Millstone Nuclear Power Station, Unit No. 1
Recirculation Loop, Small Break, Flow Split Model

MILLSTONE NUCLEAR POWER STATION, UNIT NO. 1

RECIRCULATION LOOP, SMALL BREAK, FLOW SPLIT MODEL

RESPONSES TO NRC QUESTIONS

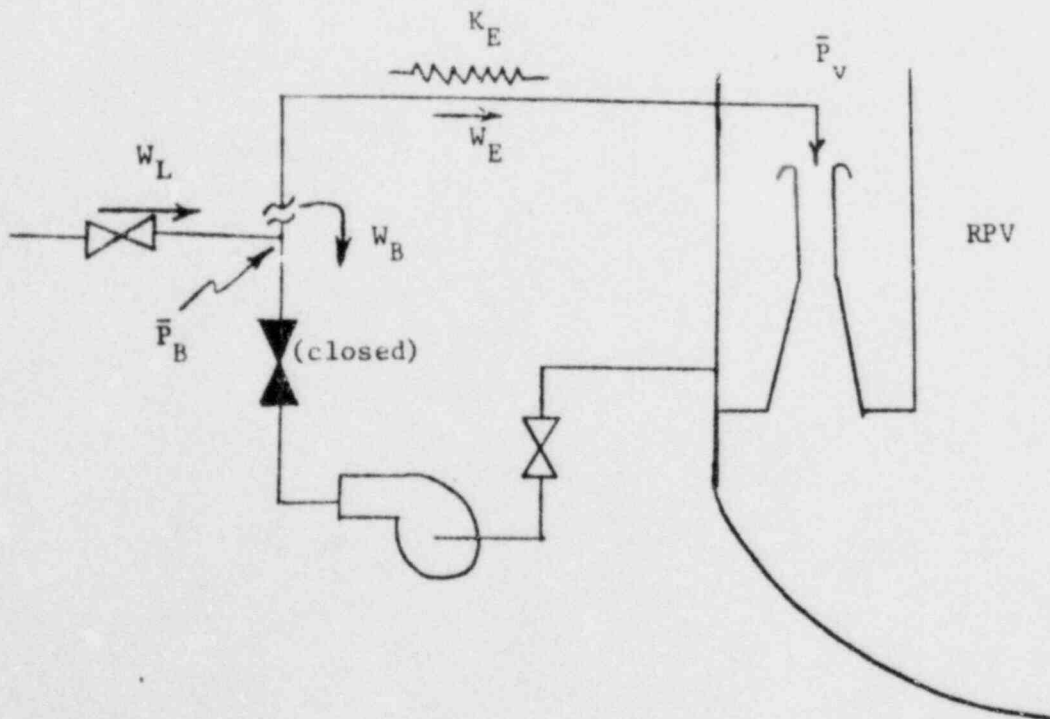
(5) Page 2; how is Equation (2) developed?

The LPCI System curve is

The energy equation from the injection point to the vessel is (see sketch below)

$$\bar{P}_B = \bar{P}_v + \frac{K_E}{288g \gamma A_E^2} W_L^2 \quad (11)$$

Substitution of Eqn (1) into (11) gives

$$\bar{P}_B = P_{vs} - BW_L^2 + \frac{K_E}{288g \gamma A_E^2} W_L^2$$

$$\text{or } W_L = \sqrt{(\bar{P}_B - P_{vs}) / (B - K_E / 288g \gamma A_E^2)}$$

as Equation (2) in Page 2
